## REGULAR OPEN MEETING OF THE UNITED LAGUNA WOODS MUTUAL ARCHITECTURAL CONTROLS AND STANDARDS COMMITTEE\*

Thursday, July 20, 2023 – 9:30 a.m.
Laguna Woods Village Board Room /Virtual Meeting
24351 El Toro Road, Laguna Woods, CA 92637

#### **NOTICE and AGENDA**

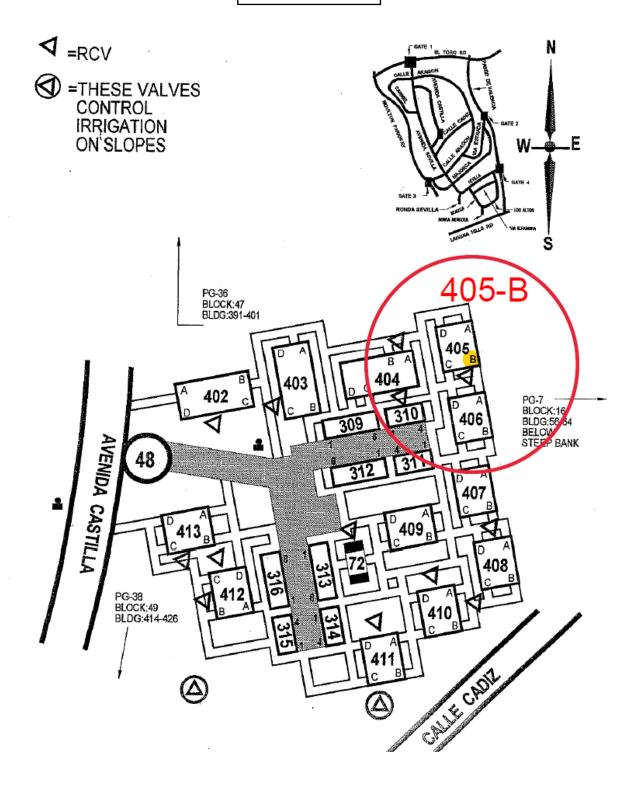
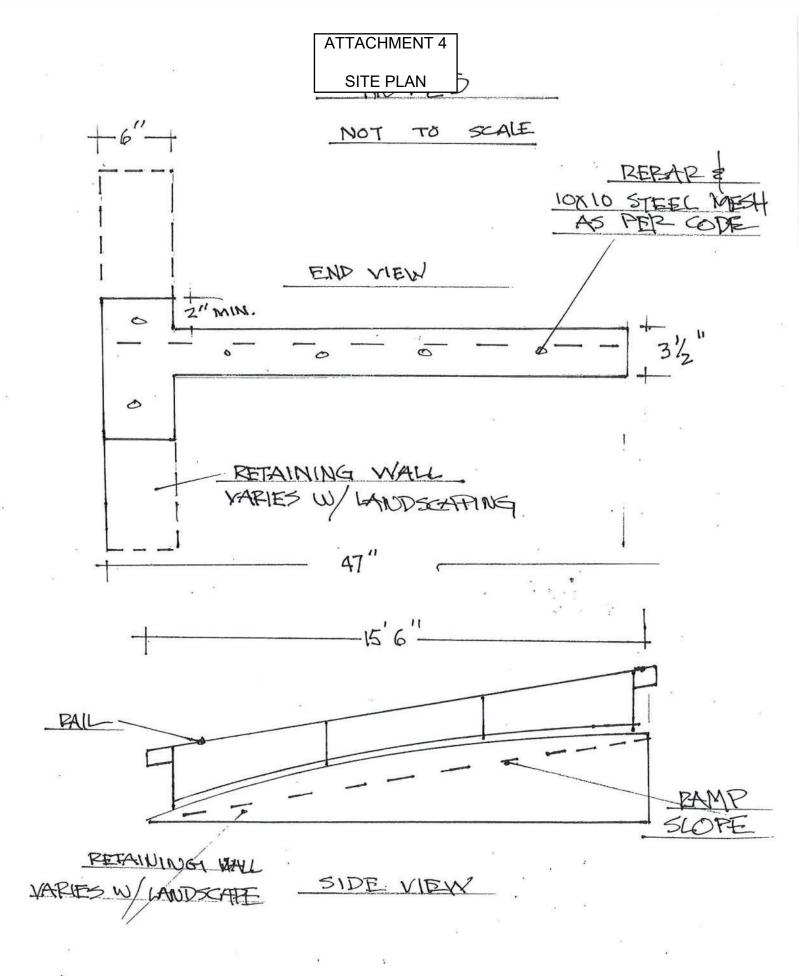
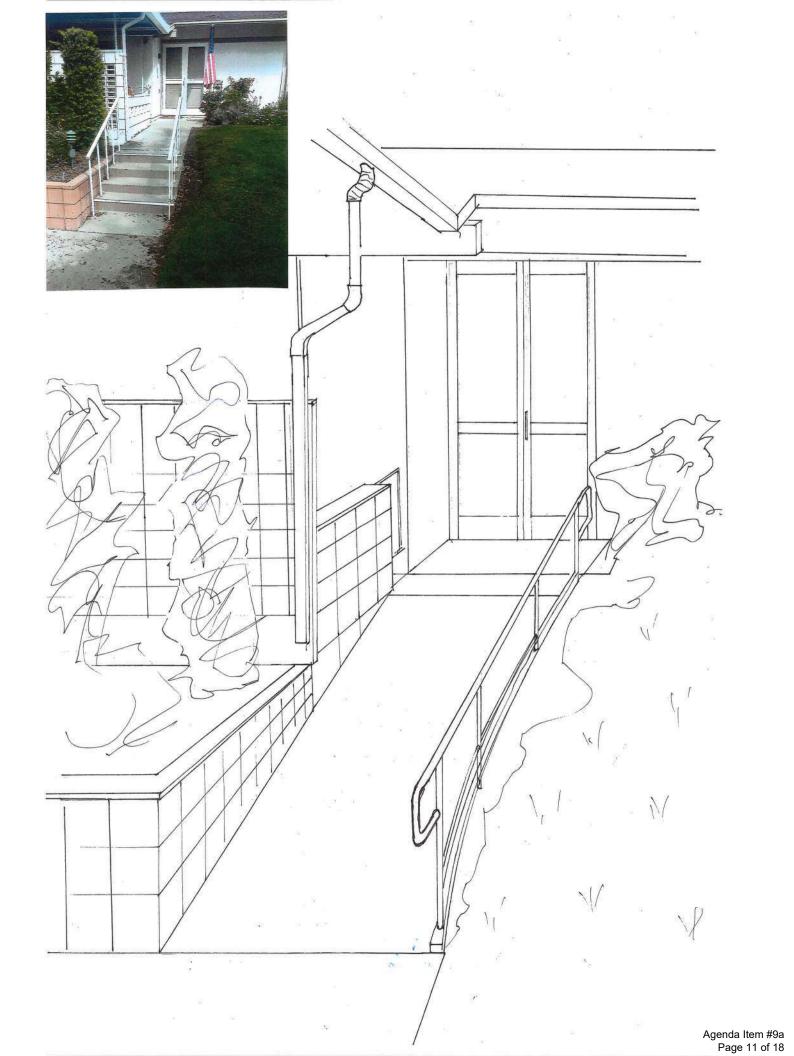
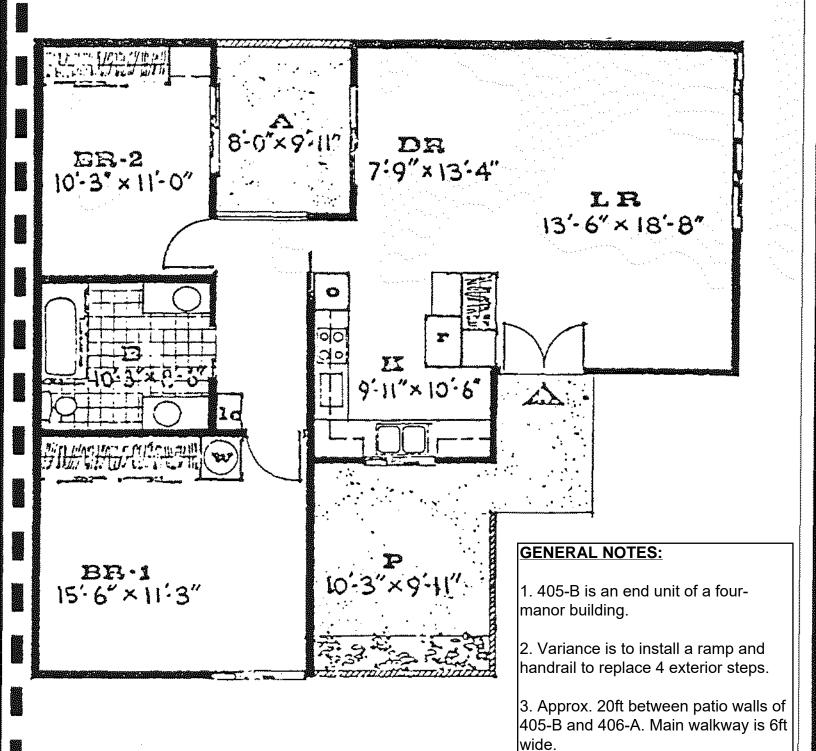
Agenda Item #9	Manor Address	Description of Request	Summary of Request and Staff Recommendation (*)
⋖	405-B	Handrail and Ramp Installation at Entry	<ul> <li>GENERAL NOTES:</li> <li>405-B is an end unit of a four-manor building.</li> <li>Variance is to install a ramp and handrail to replace 4 exterior steps.</li> <li>Approx. 20ft between patio walls of 405-B and 406-A. Main walkway is 6ft wide.</li> <li>Retaining wall would be required on North East facing portion of ramp due to the landscape area.</li> <li>Staff Recommendation: Approve</li> </ul>
Δ	2010-C	Polycarbonate Patio Cover on Front Patio	<ul> <li>2010-C is an inside unit of a four-manor building.</li> <li>Variance to install non -standard polycarbonate panels to replace existing patio cover.</li> <li>Existing Patio cover was approved with Mutual Consent # 8177 in 1969.</li> <li>Standard 20: Patio Covers; Aluminum and Vinyl states in section 2.8 Plexiglas, corrugated fiberglass, and similar coverings will not be permitted.</li> </ul> Staff Recommendation: Deny

4. Retaining wall would be required on North East facing portion of ramp due

to the landscape area.

# 484 – D Stairs relocate

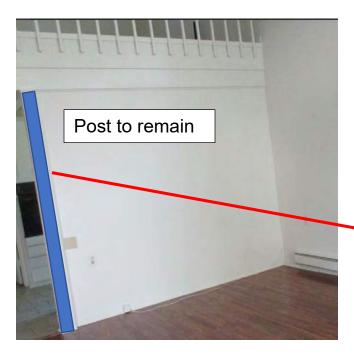
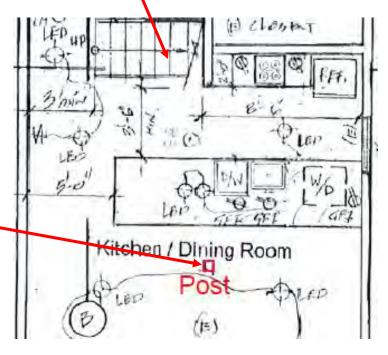
- 484-D is a four manor building
- Variance is for interior stair relocation and bathroom remodel.
- Kitchen demo and build back has the post for the loft exposed outside the kitchen in the living room.
- City plan check and permit process will require all work to be code compliant
